N5230A-01C

S E R V I C E N O T E

N5230A PNA Series RF Network Analyzers

Serial Numbers: 00000000 thru 46999999

Figure 1

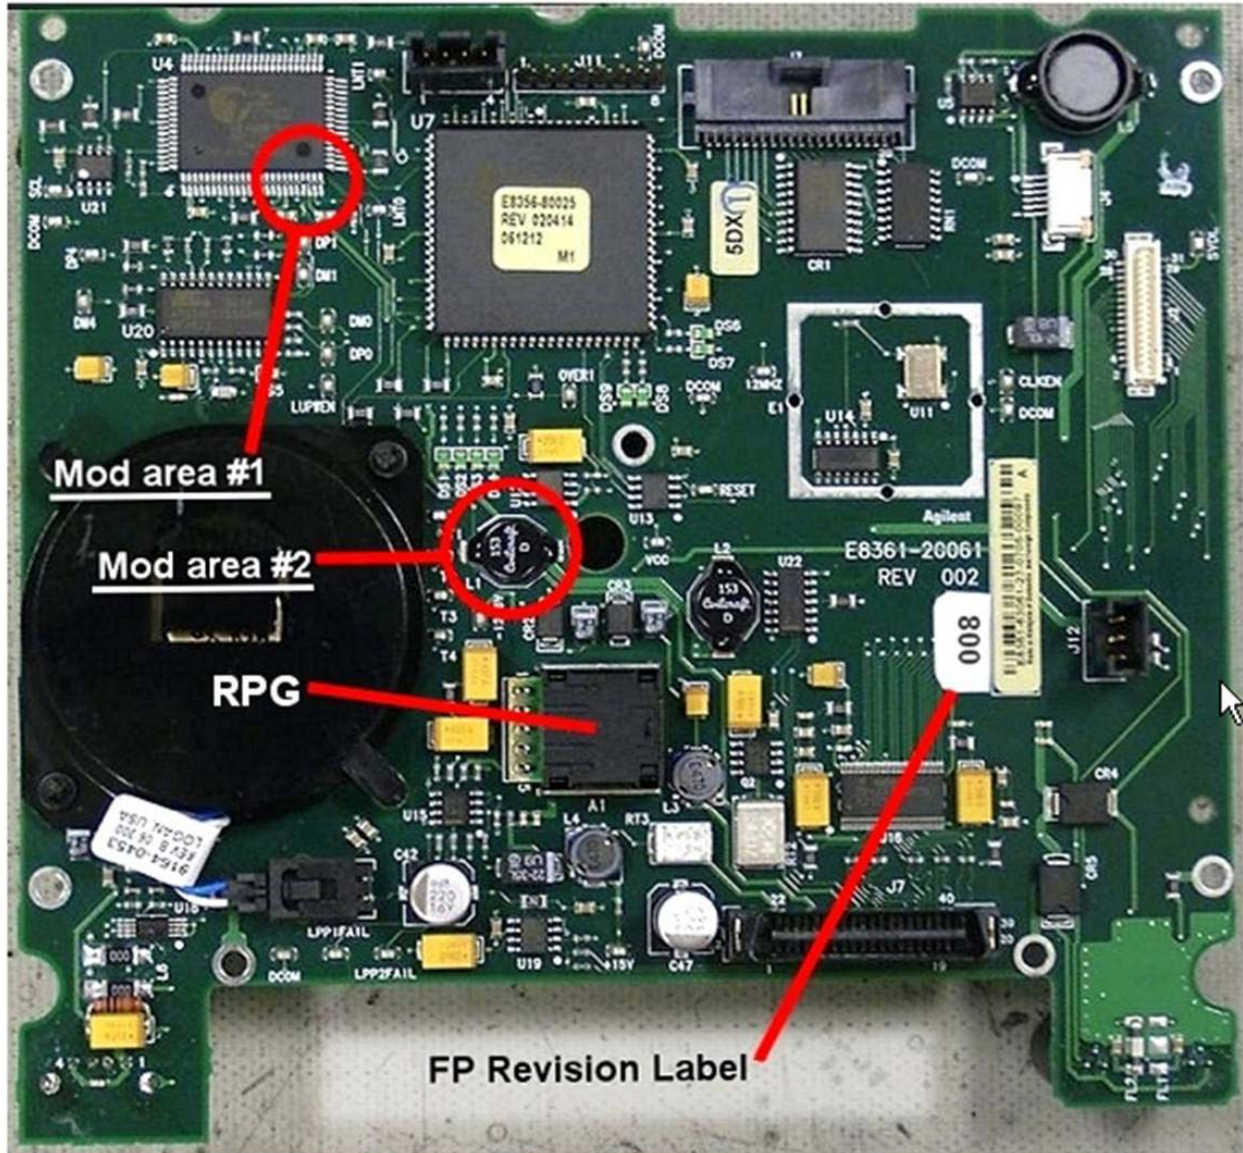
Refer to Figure 1 for the two modification areas to be addressed. Note that while this picture happens to show the FPI board completely removed from the front frame assembly, this is not necessary to perform the required modifications.

- Modification #1 consists of shorting two pins of U4 together with a small amount of solder.
- Modification #2 consist of removing L1.

Figure 2

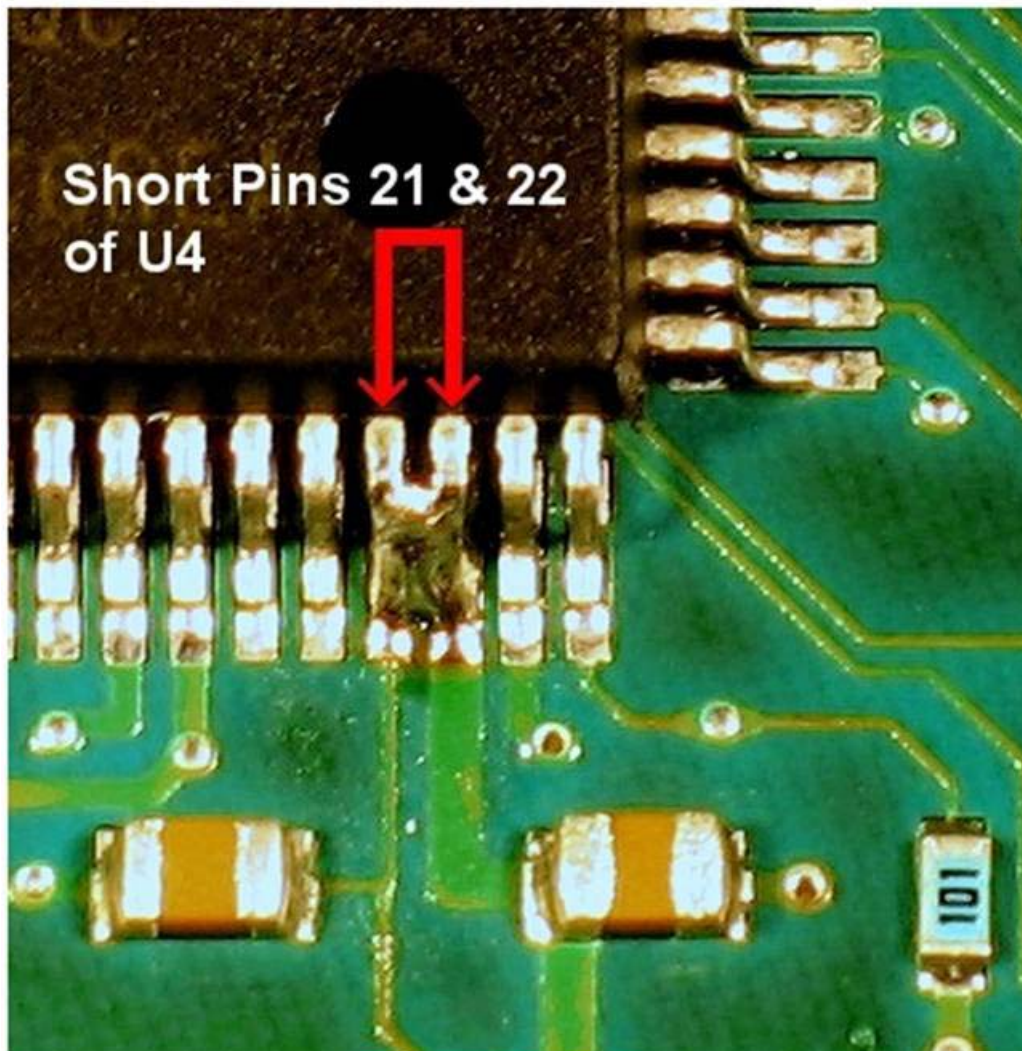
Carefully solder pins 21 and 22 together on U4. Refer to Figure 2 for the exact location. Use care so that no other pins are shorted. Use of a very fine tip soldering iron is recommended and a large work-task magnifying glass is very helpful.

Unsolder and completely remove the black surface mount inductor L1 from the front panel assembly board. This is no longer needed and can be discarded.
